Access Compliance Report

Public Rights-of-Way

(Pedestrian Signals)

Intersection ID: N/A	Main Street:	Cross Street: N/A	Location: N/A
ADA ID: EDD5FFBBA550	Signal Type: Two Push Buttons-Non APS	Overall Compliance: No	Severity Score: BTN 1:N/A BTN 2: N/A No BTN: N/A
Codes/Mitigation Info/Possible Solution		Field Measurements/Component Compliance

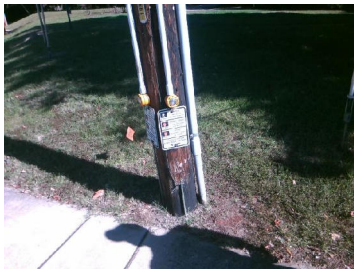
PROW/ADA: TMUTCD 4e.08, R404.2, R404.3, R406.2

Yes	B 1 Clear Xing Direction?	ClearlyMarked	Yes	B 2 Clear Xing Direction?	ClearlyMarked
	B 1 Crossing Direction	To SW		B 2 Crossing Direction	To NW
Yes	B 1 DistanceTo XWalk (in)	0.0	Yes	B 2 DistanceTo XWalk (in)	0.0
No	B 1 DistanceTo Curb (in)	98.0	No	B 2 DistanceTo Curb (in)	99.0
Yes	B 1 Diameter (in)	2.0	Yes	B 2 Diameter (in)	2.0

Possible Solutions: Replace Signal Push Button With APS Button on New Post. Remove & Relocate Sign.
